nd Management Parameters for 10 Mb/s Operation and Associated Power Delivery over a Single Balance

Power Management Parameters for 10 Mb/s Operation and Associated Power Delivery over a Single Balance

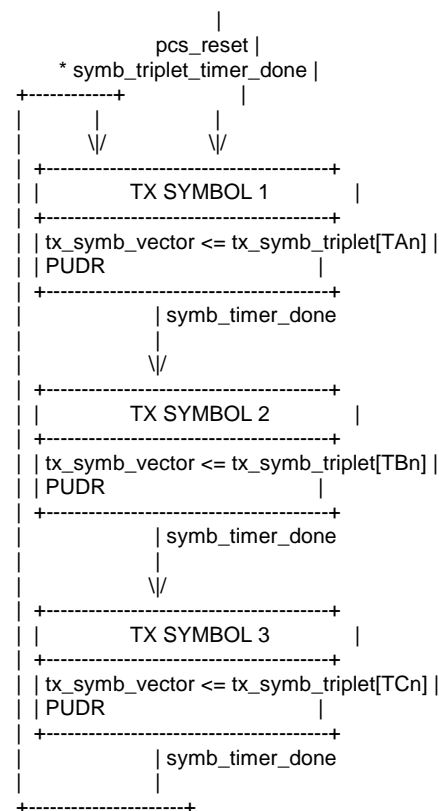
Is it correct that 'The PCS Transmit function shall conform to the PCS Transmit state diagram in Figure 146-5 ...' and that 'In each symbol period, PCS Transmit generates a symbol An provided to the PMA ...'? The PCS Transmit state diagram in Figure 146-5 changes state based on STD being true, with STD being an alias for symb_triplet_timer_done, and the output of the PCS Transmit state diagram is tx_symb_triplet which is defined in subclause 146.3.3.1.1 'Variables' as 'A triplet of ternary symbols generated by the PCS Transmit function after 4B3T encoding.'

I think the problem is that there is another function within the PCS Transmit function that is missing from the PCS Transmit state diagram in Figure 146-5, the 'multiplexor' shown in Figure 146-6 'PCS transmit symbol generation'. This 'multiplexor' function operates at the symbol clock rate and serialises the tx_symb_triplet code-groups output by the PCS Transmit state diagram into individual symbols.

This may also explain when subclause 146.3.3.1.3 'Timers' defines the symb_timer that is not used in the PCS Transmit state diagram in Figure 146-5.

[2] Add a new subclause 146.3.3.2.1 titled 'Variables' that reads:

[4] Add a new subclause 146.3.3.2.2 titled 'Timers'. Move the symb_timer definition from subclause 146.3.3.1.3 Timers to this new subclause.

[5] Add a new subclause 146.3.3.2.4 'Abbreviations' that reads:

[6] Insert a new Figure 145-6 shown below (view using a non-proportional font such as courier), renumbering the following figures as required.

subclause is describing, change the text '... the PCS Transmit function passes ...' in the current third paragraph to read '... the PCS Transmit state diagram passes ...'.
